Attachment 1 – Staff Verification of the Vertical Anisotropy to the HJ Horizon Lost Creek, Wyoming

Attachment 1 Figure 1-9 NRC model-predicted potentiometric surface in Zone 3 with long-term operations for the Selected Modules in Zone 3 and Zone 4

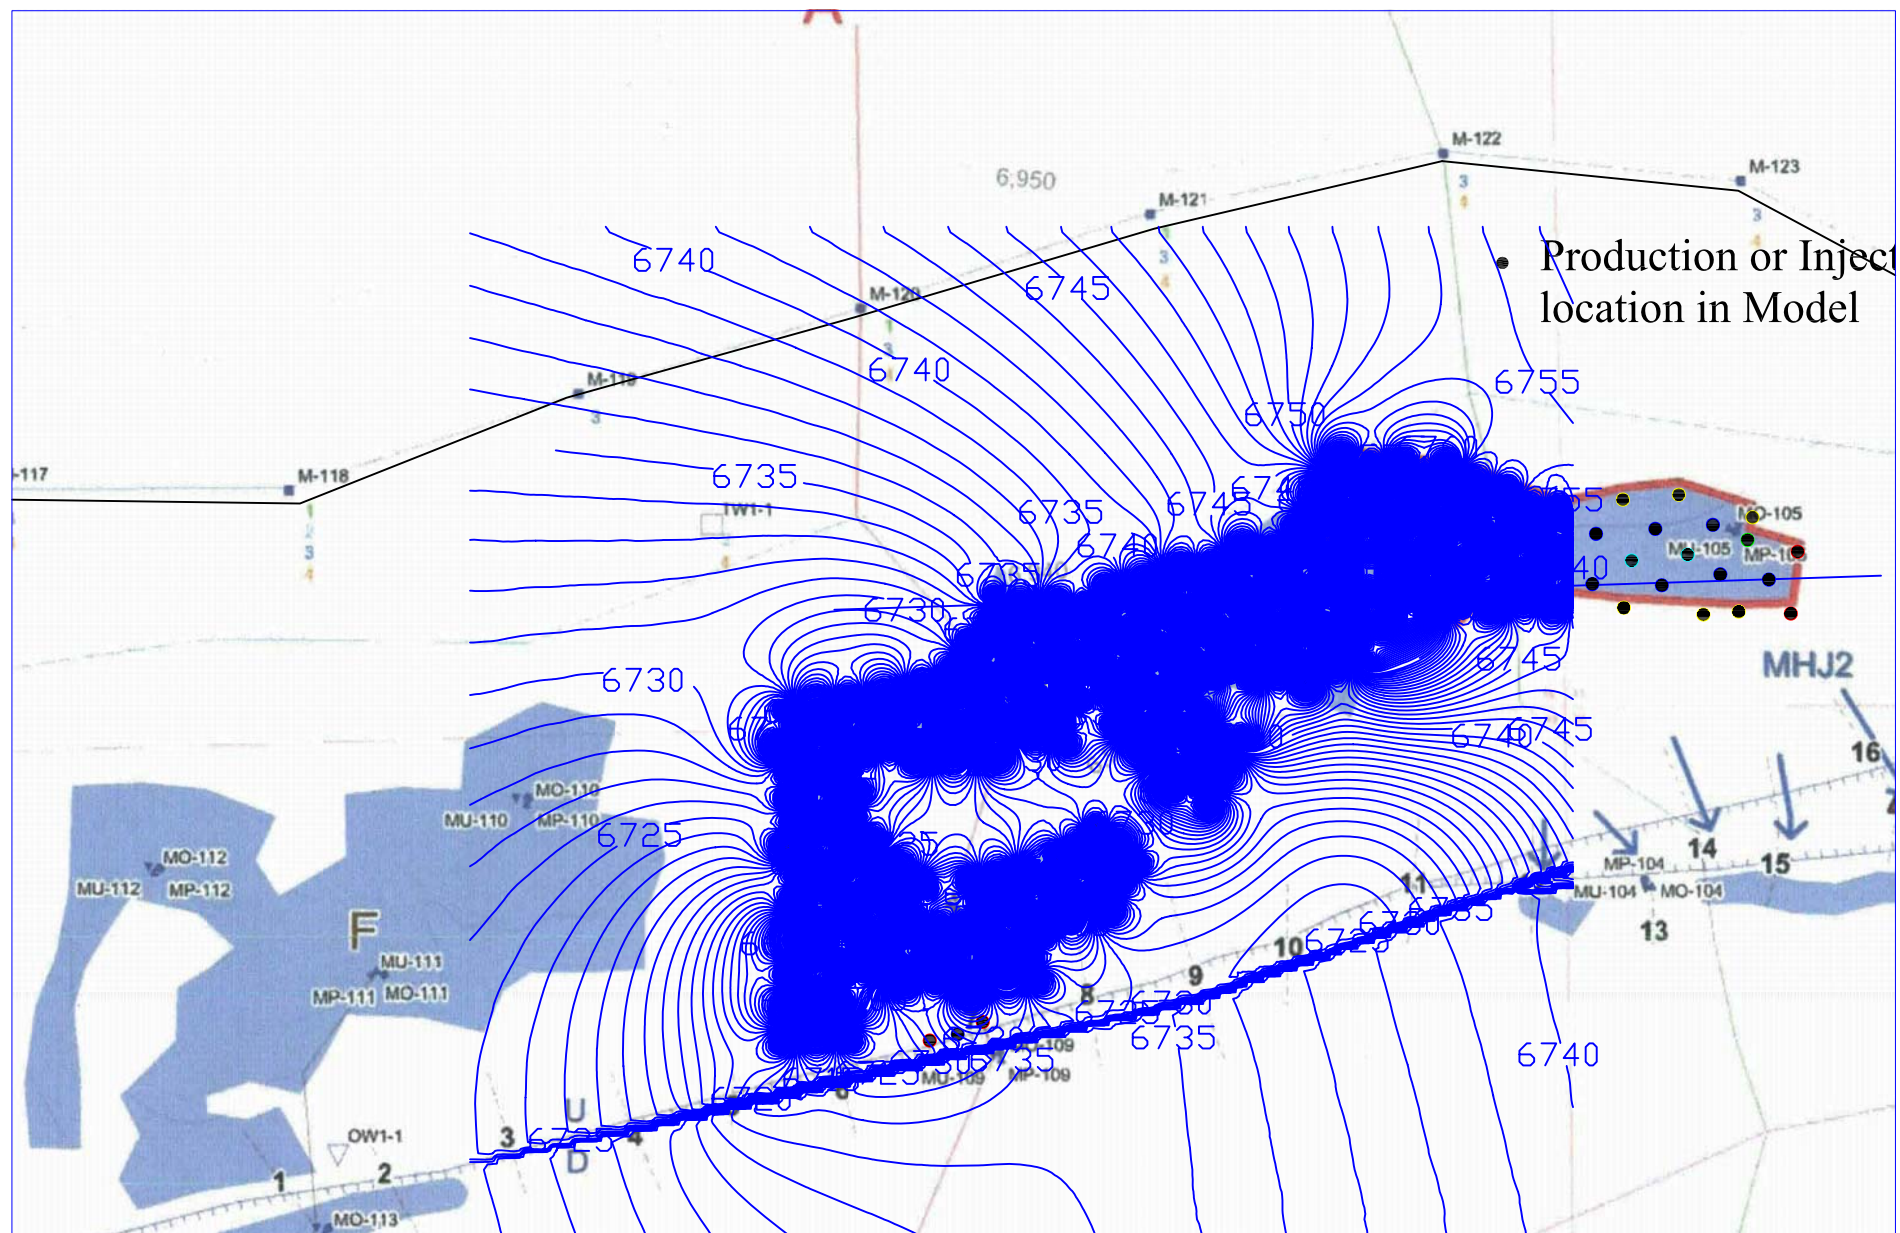
A contour map of the potentiometric heads in Zone 3 is shown on Attachment 1 Figure 1-9. The contours indicate a depression exists along the fault south of production area. The contours indicated that lixiviant in Zone 3 will migrate to the depression and similarly into the open area surrounded by the production units. Similar depressions in the piezometric surface in other areas along the fault are shown by the licensee in figures in the MU-1 Attachment 5-1, Numerical Hydrologic Model of MU1.

At the present time, Lost Creek has not proposed monitoring in these areas nor have they been included in estimate in the flare factor for financial surety calculations.
